project no: 12/03
 project title: Impact 2
 location: Edward Street SHEFFIELD
 drawing no: 003
 drawing title: LEVEL 0 PLAN

revision: 1
 date: Sept 2013
 drawn by: 1:100 @ A1
 approved by:
 drawing status: FOR CONSTRUCTION

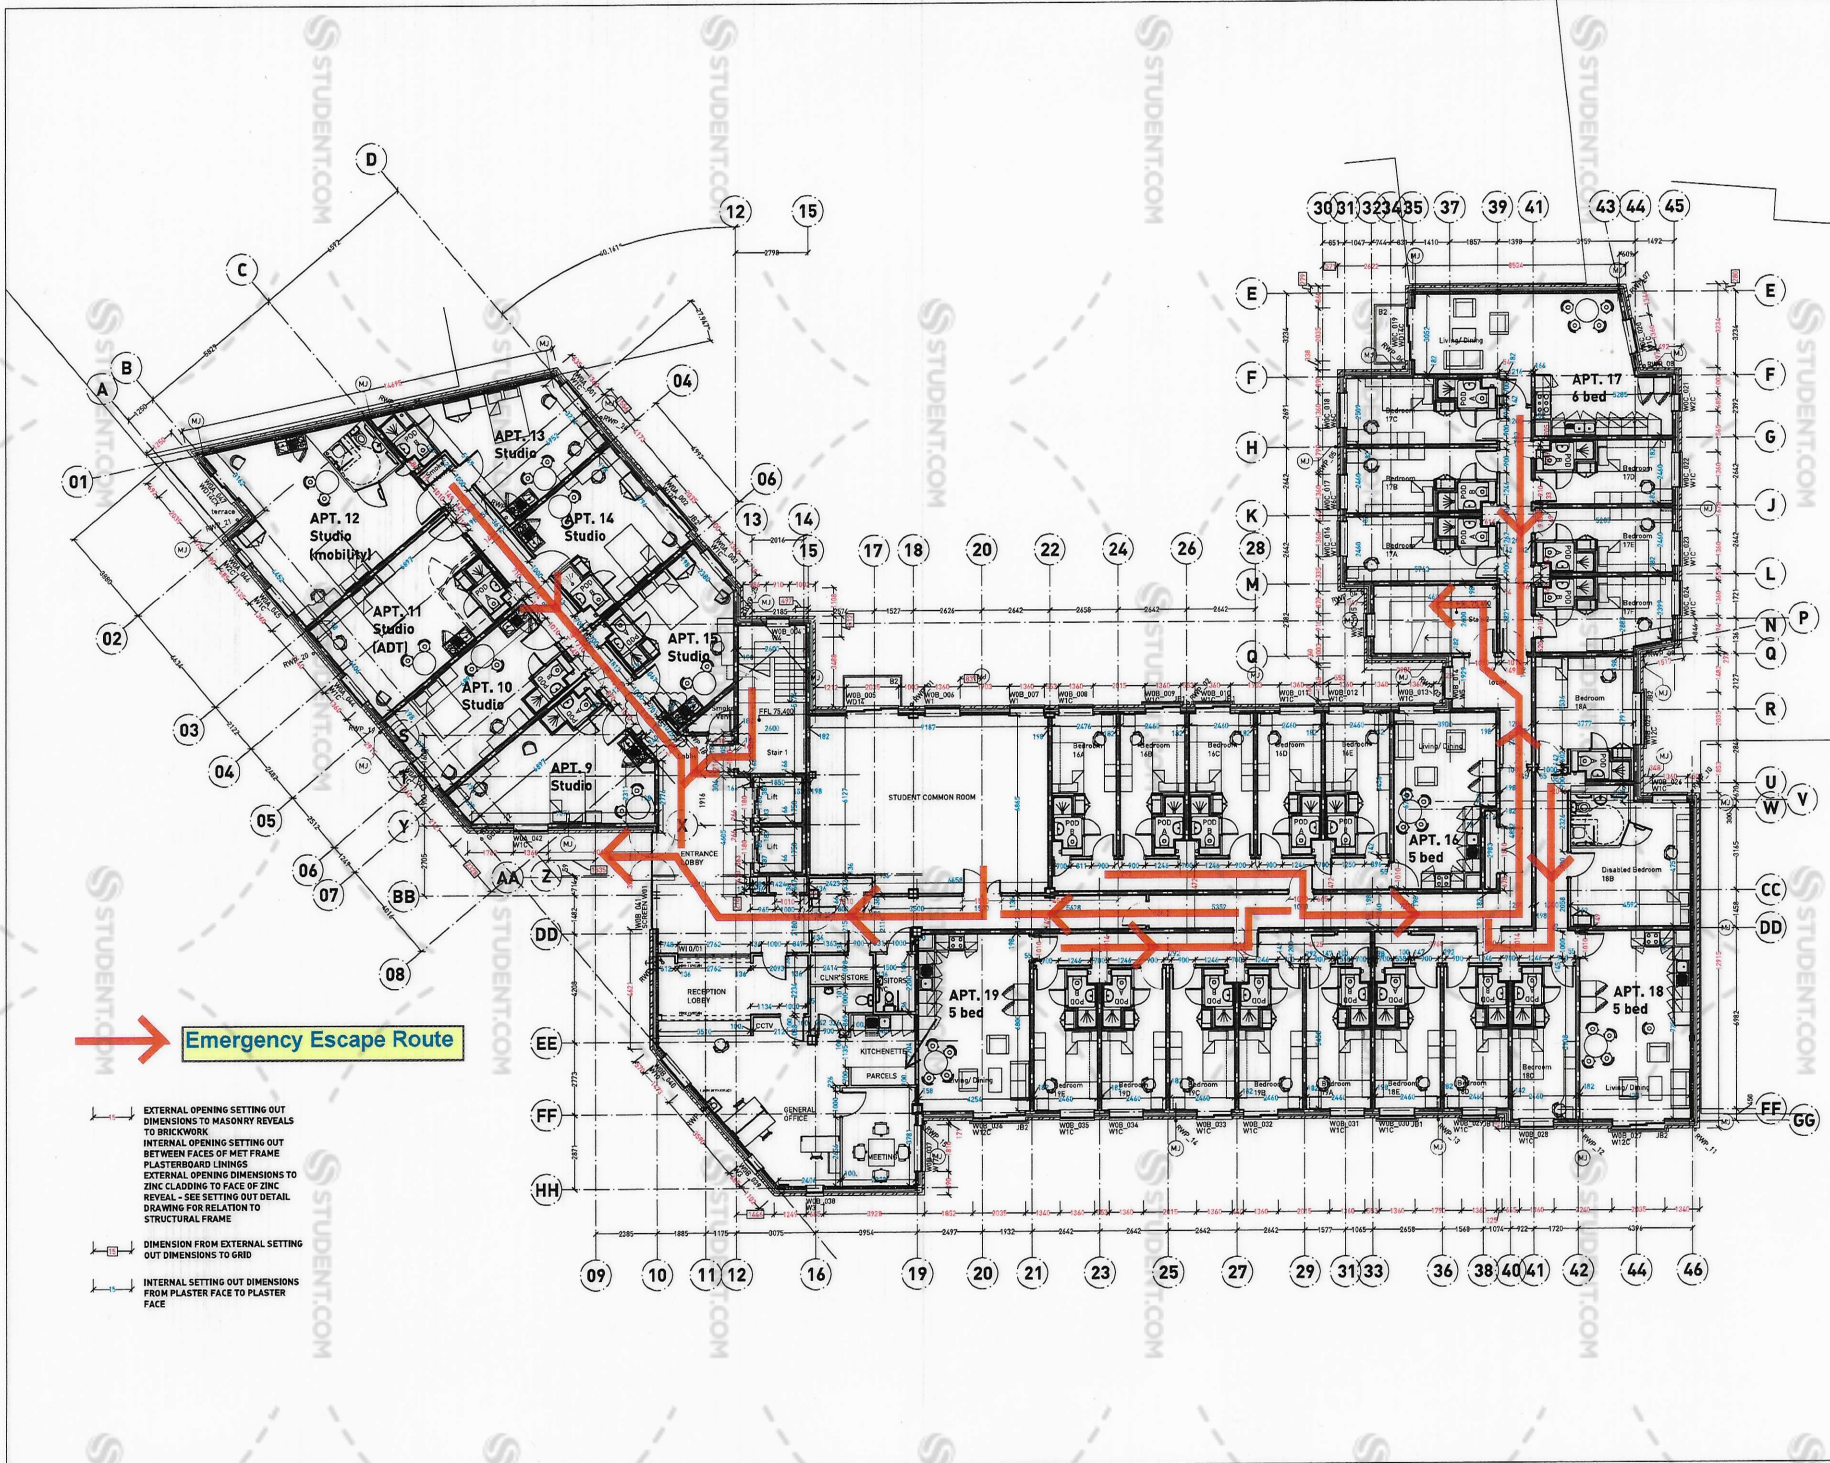
- Revision - Date**
- Rev A - 28/03/13 Internal Structural Opening Setting Out dimensions added, way to dimensions added, Wall 04114 increased to include 182 Met DD042-46 corrected to 182. Grid 17 corrected 100mm towards grid 18. Note regarding revision 182 Met added.

- Rev B - 02/10/13 Internal construction. Staircase 1 rear wall and associated gridline P moved by 502mm to enable staircase walls to align as requested by AM. External floor level corrected to coincide with M&E consultants requirements. Grids 17 & 34 is structural Met Frame. Also wall between Apt 14 and Apt 45 corridor revised to be structural Met Frame. All as requested by PAW. Dry rise added to Stair 2.

- Rev C - 09/03/13 The columns added, lift openings added, room numbers amended to have better reference, reception and APT (apartments) rooms amended as instructed, finish floor levels added, main entrance door repositioned, movement joints and staircase door added.

- Rev D - 04/11/13 Narrow pod rear door revised to 1000mm & structural fire enclosure removed as instructed by contractor, position of final landing window to stair 1 revised, dry rise outlet box dims indicated, management area layout revised, door position to common room revised clear of bracing, balcony references, laundry extract rear added.

- Rev E - 22/01/14 Reception lobby wall arrangement revised, fire curtains added, access corridor door to block A omitted, call as requested by fire consultant. Window referencing added.

- Rev F - 28/02/14 Smoke vent added to Block A as required by B.Control, Apt 13 pod access door relocated, Apt 12 disabled bathroom repositioned, kitchen & studio layouts indicated, window W04_045 & adjacent brick pier revised to LPA requirement, dimension to gridline P corrected, additional plaster face one added to NB apartment.

- Rev G - 10/03/14 Dims to studio entrance doors to Apts 13, 14 & 15 revised to 1000mm.
 - Rev H - 28/04/14 Window W04_047 to Apt 12 & adjacent brick pier revised to LPA requirement.

- Rev I - 18/05/14 Door average revised to stair 1 and block A corridor to enable mechanical venting to Block A smoke shaft.
